UNITED STATES PATENT AND TRADEMARK OFFICE

APPLICATION NO.	FILING DATE	FIRST NAMED INVENTOR	ATTORNEY DOCKET NO.	CONFIRMATION NO.
10/527,131	03/08/2005	Manabu Takagi	0670-7054	9429
7590 03/26/2008 Robinson Intellectual Property Law Office PMB 955 21010 Southbank Street Potomac Falls, VA 20165			EXAMINER	
			HUNTER, QUINN T	
			ART UNIT	PAPER NUMBER
			4147	
			MAIL DATE	DELIVERY MODE
			03/26/2008	PAPER

Office Action Summary	Application No. 10/527,131	Applicant(s) TAKAGI ET AL.
	Examiner QUINN HUNTER	Art Unit 4147

DETAILED ACTION

Figs 4 and 6 Munch et al enclosed

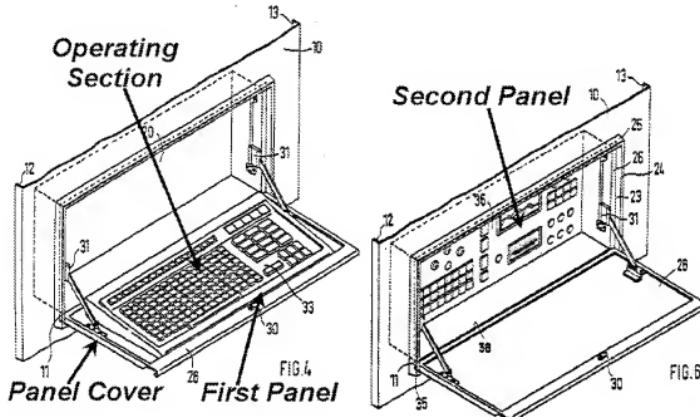
- wherein a motor for controlling the rotation position of the first panel independently from the movement position of said slider, is provided
6. Munch et al teaches that for an mounted electronic apparatus housing, in addition to a second panel (See Munch et al enclosed below), may also have a first panel and panel cover on the front of the housing (See Munch et al enclosed below) with an operating section (See Munch et al enclosed below). This first panel is capable of rotating to be juxtaposed vertically to face the second panel (col 3, lines 30-33). Use of these two panels in a cooperative arrangement is disclosed by Munch et al (col 1, lines 58-60). It would have been obvious to one skilled in the art at the time the

invention was made to modify an electronic apparatus housing of Shibuya to include another panel, as taught by Munch et al, to have additional input controls that may be neatly stored away.
